This submission is in regard to the Official Plan Amendments and Zoning By-law Amendments proposed for the Barrie Lakeshore 51-75 Bradford Street/20 Checkley Street submitted by Smart Centres on behalf of Lakeshore Developments of (Bradford/Checkley) the above locations.

CONCERNING: Official Plan Amendment and Amendment to the Zoning By-Law - Smart Centres on behalf of Barrie Lakeshore Developments, 51-75 Bradford Street & 20 Checkley Street, Barrie.

Re: File: D09-OPA078, D14-1692, dated May 14, 2020

Drawing showing overwhelming scale of Proponents Podium versus the 2 Toronto St. Podium

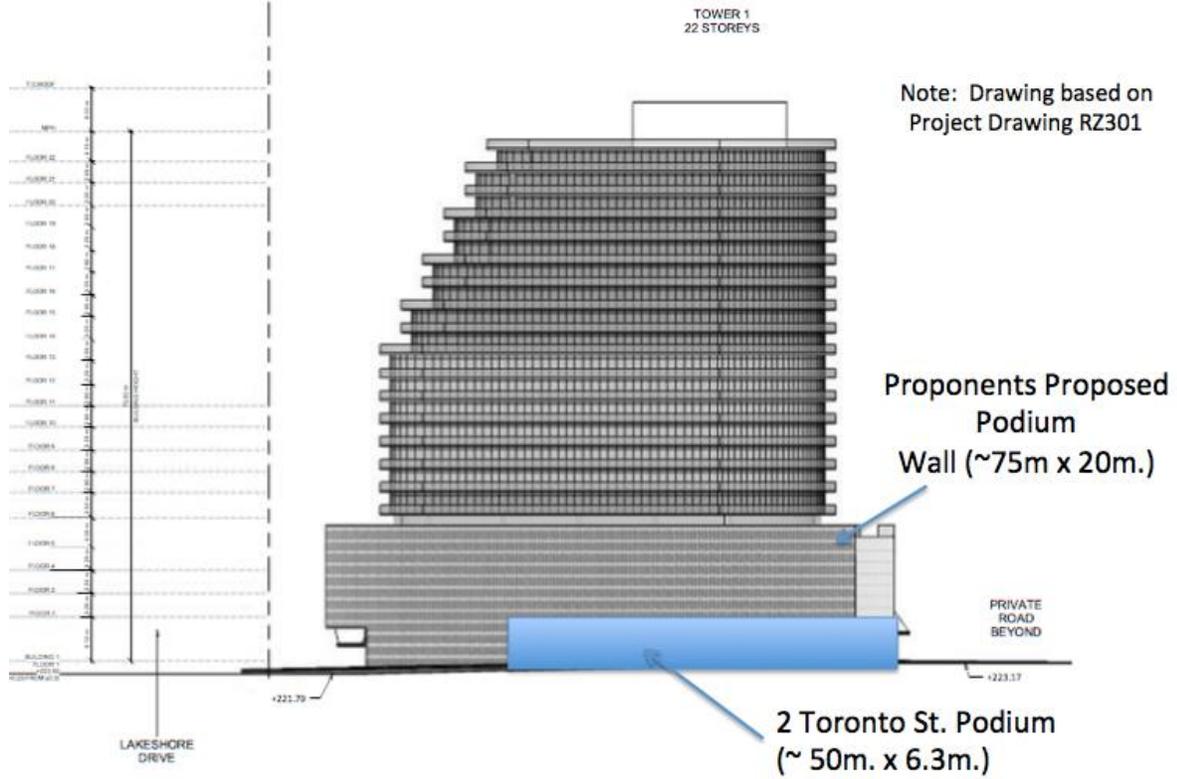
I like to think that actions speak louder than words. Good neighbours are those that have concern for each other and show it by what they do. The proponent is requesting approval to construct the building #1 podium (walls) that in my opinion are both too out of scale and too tall relative to the adjacent 2 Toronto St terrace. Unlike the words of the

Specifically, the proponents’ building 1 proposal consists of a five story (65 ft.) structure that will tower 45 ft. above the terrace of the adjacent podium. The height differential, is the height of three Berlin walls, or by more than the Great Wall of China, or by even more than the US Mexico border wall. Rather than approve this, I suggest that the proponent be requested to mirror the podium height and setback to that which exists at 2 Toronto St. This change would then have two high rise structures each set back from the lot line by similar amounts and both having terraces at the same height.

For reference, the approximate height of the proposed podium above the current 2 Toronto St. terrace is three stories or approximately 45 Ft. (12 m.) In contrast:

A good neighbour does not build a huge wall along his neighbour’s property line. Again, the request is to reduce the podium structure between the new and existing residential structures such that it mirrors the existing podium of 2 Toronto St.

This request should also be considered regarding the proposed five story podium for buildings 2&3. Again the proponent is proposing structures that are more than double the height of the adjacent buildings. See drawing on page 5.
